State of Utah
DEPARTMENT OF NATURAL RESOURCES
DIVISION OF OIL, GAS AND MINING

Re: Revised Minor Coal Exploration Permit, Cyprus Plateau Mining Company, Willow Creek Mine, ACT/007/038-97G, File #3, Carbon County, Utah

RE: Notice of Intent to Conduct Minor Coal Exploration, Revision to Exploration Permit Application ACT/007/038-97G, Cyprus Plateau Mining Corporation, Willow Creek Mine, Carbon County, Utah

NOTICE OF INTENT TO CONDUCT
MINOR COAL EXPLORATION
Willow Creek Mine

Figure 6

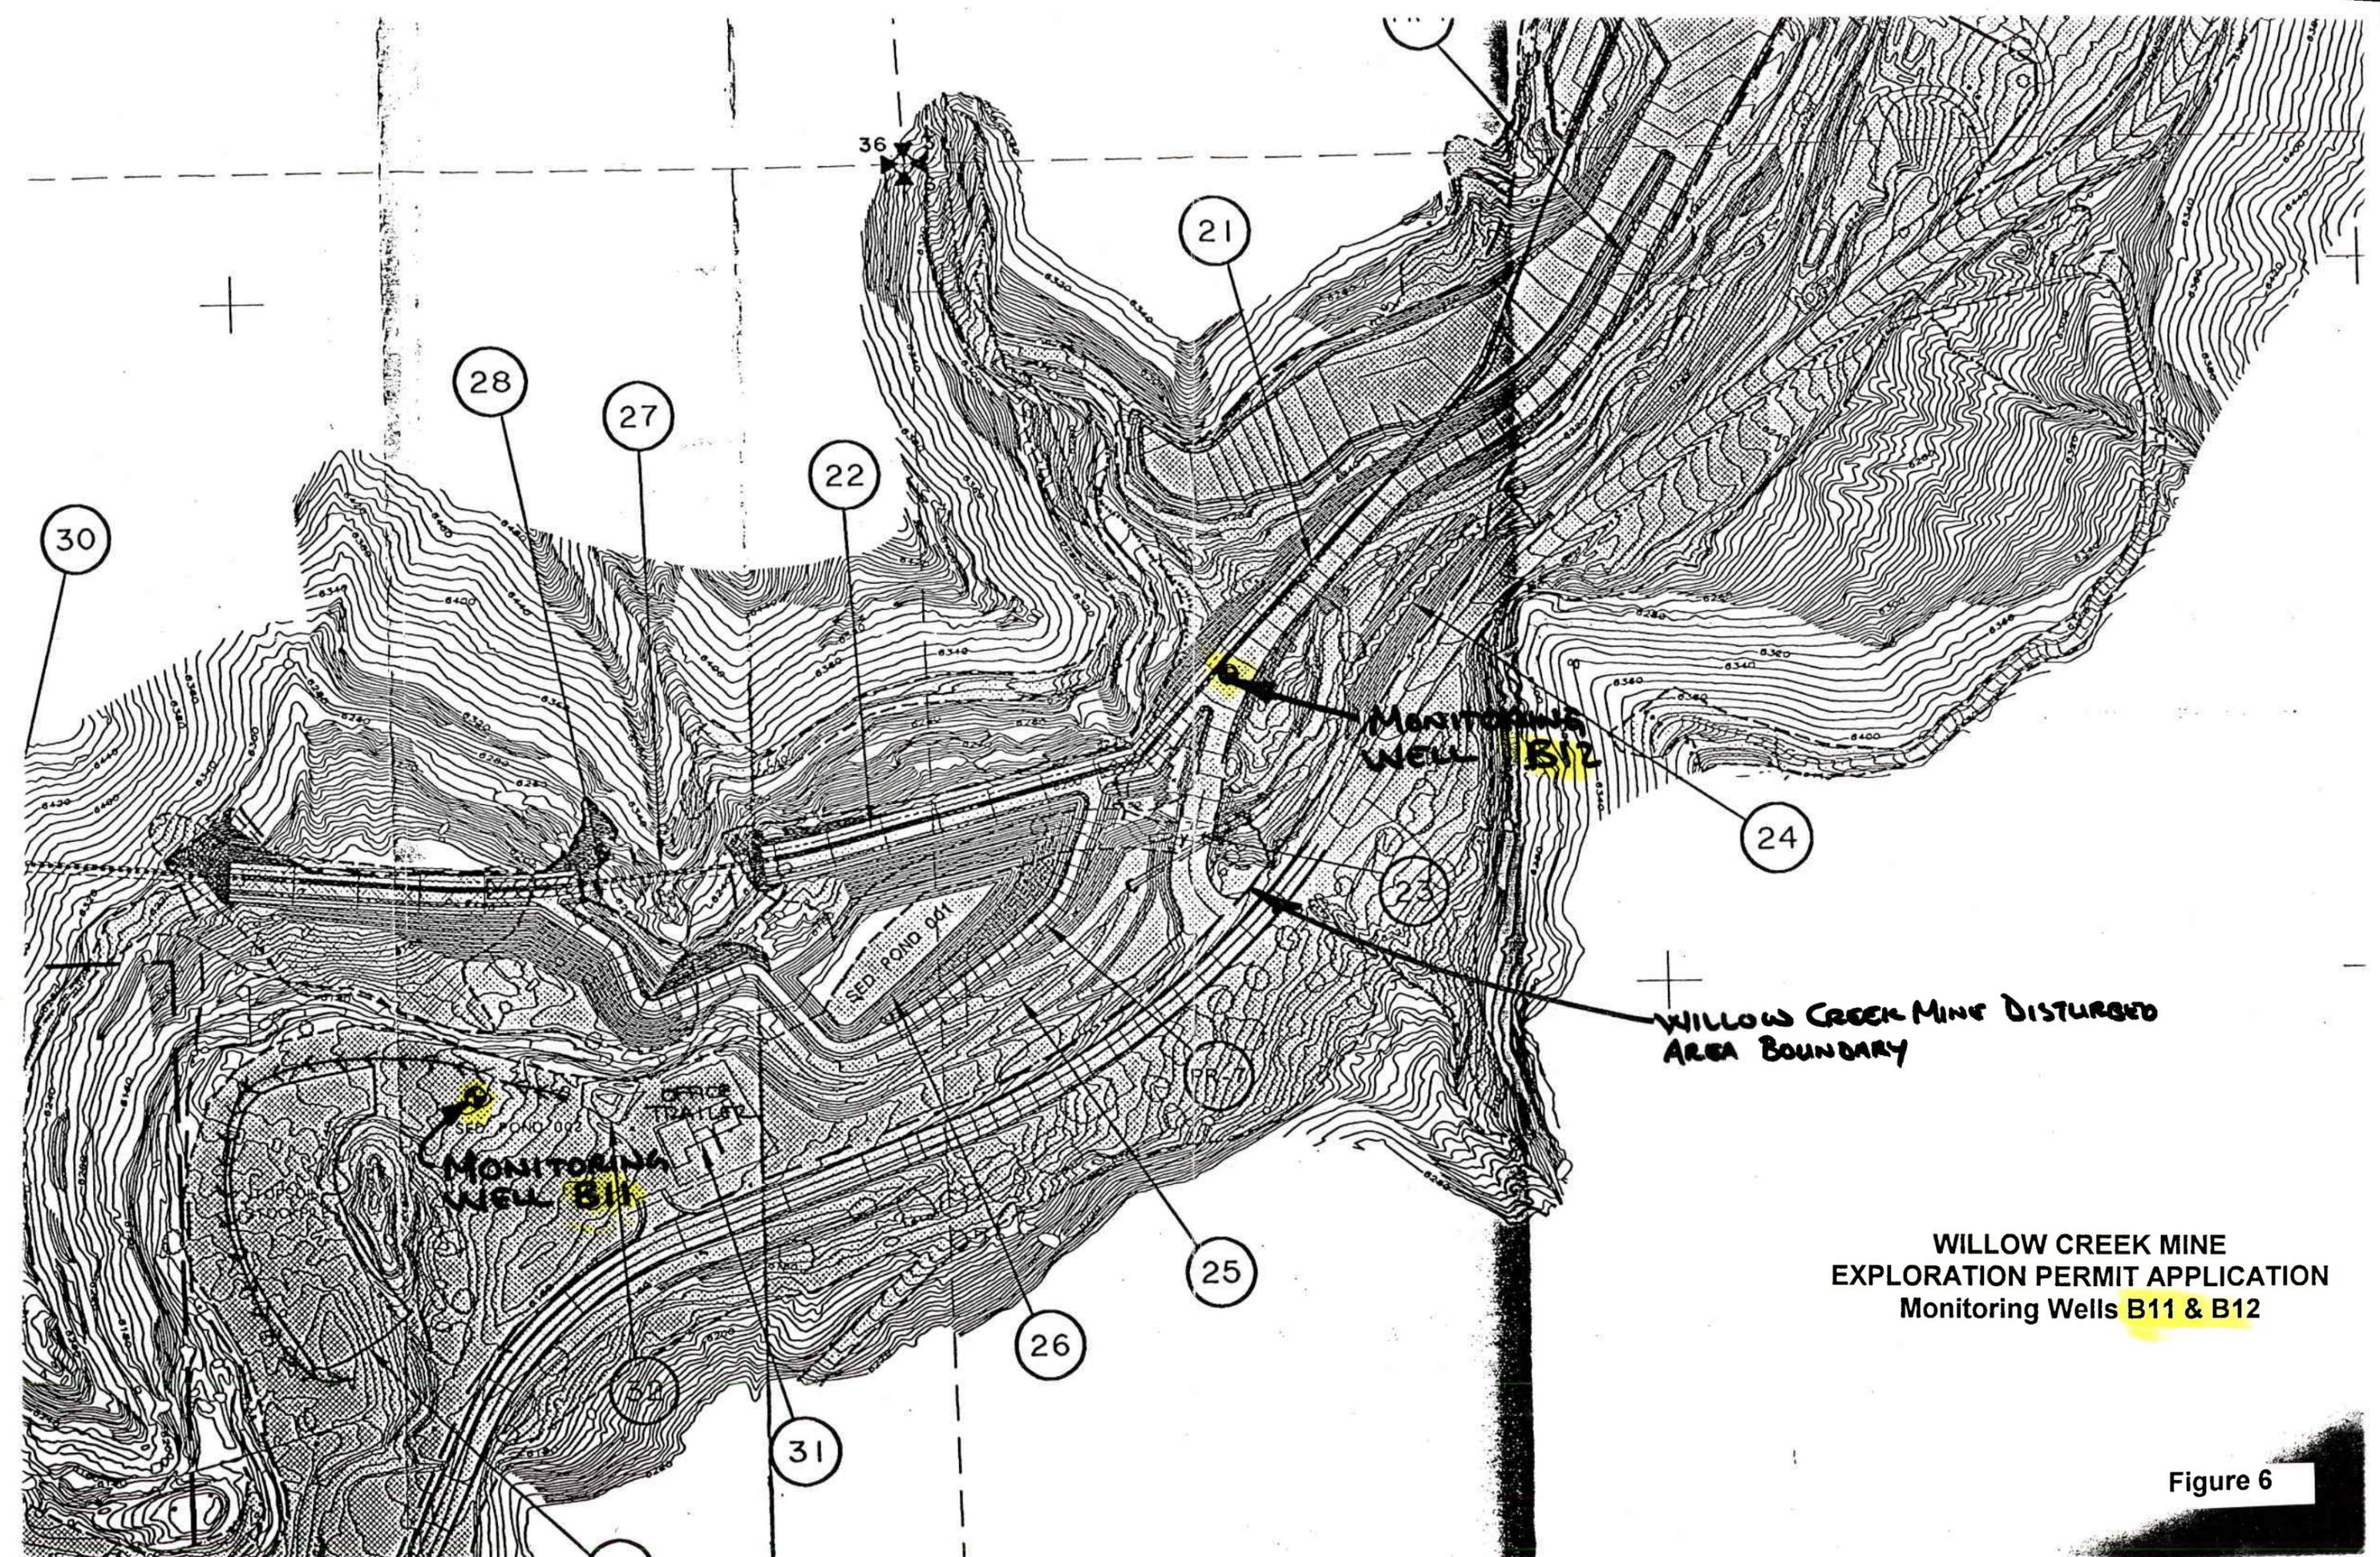
Is there such a thing as a crowd-sparking
bit? Is there a vent pipe in the
cap? Is the cap of sufficient
strength to support rig or associated
equipment? Will certified mine foreman
be on duty?

Is MSHA aware of Cyprus-Plateau's Plans

4) Monitoring Well B-354
for exploration & ground water
monitoring into old workings
